COBRA Guidance Note

Clients have reported cracking on the COBRA Head and Upper Plenum at the pockets for the M8 inserts.

Figure 2 - Capscrew locations

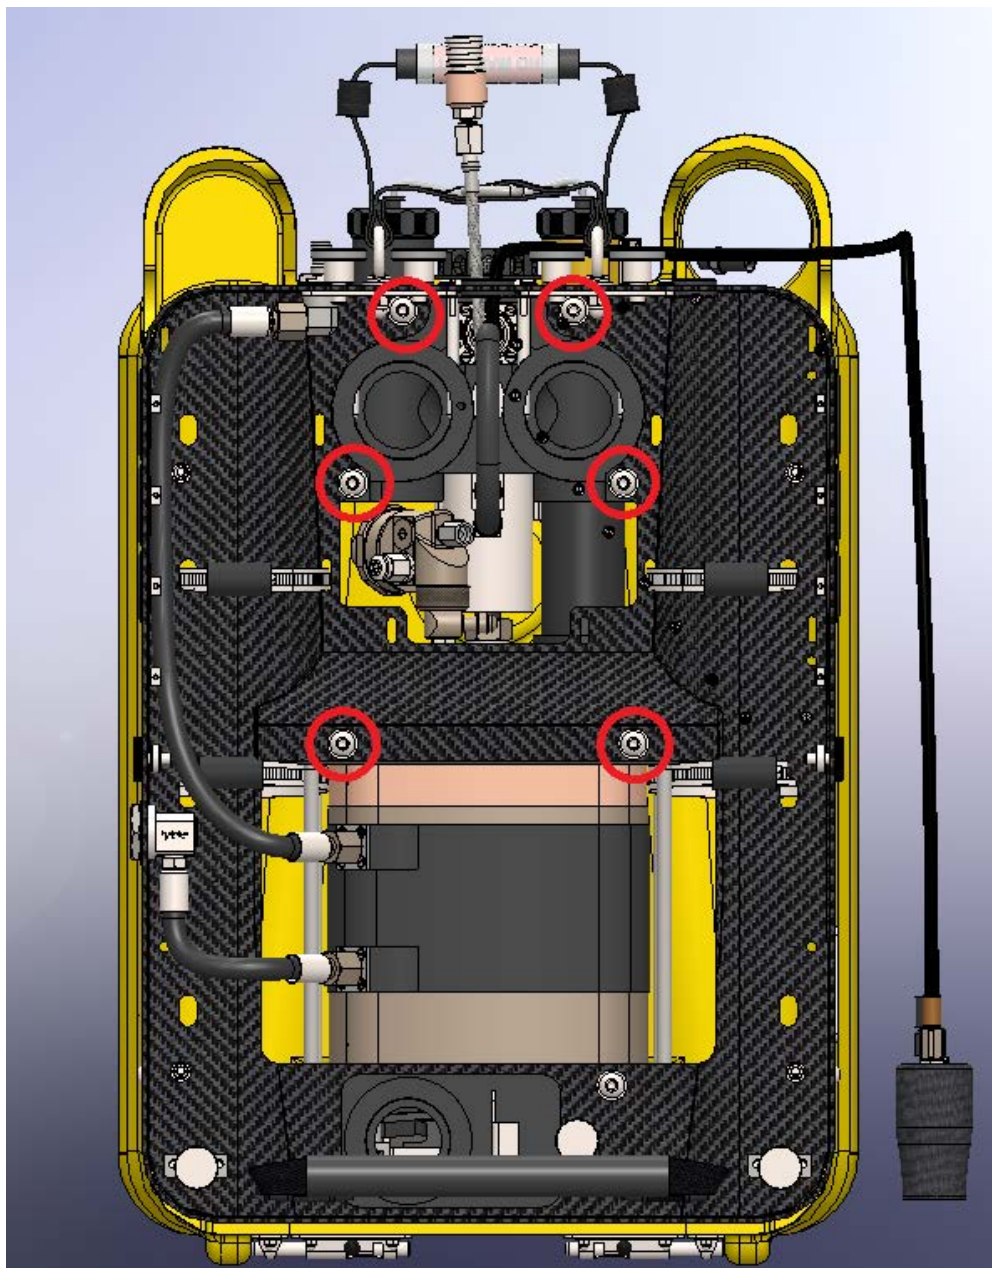
More recently, a client reported the issue on a newly supplied COBRA set and also provided information that identified the cause was an overly long cap screw bottoming out on the back of the insert pocket.

JFD will supply a 16mm length cap screw to all COBRA users which will resolve the issue. The screws in the locations marked in Figure 2 should be removed and discarded and the replacements fitted. Torque to 25 inch-pounds.
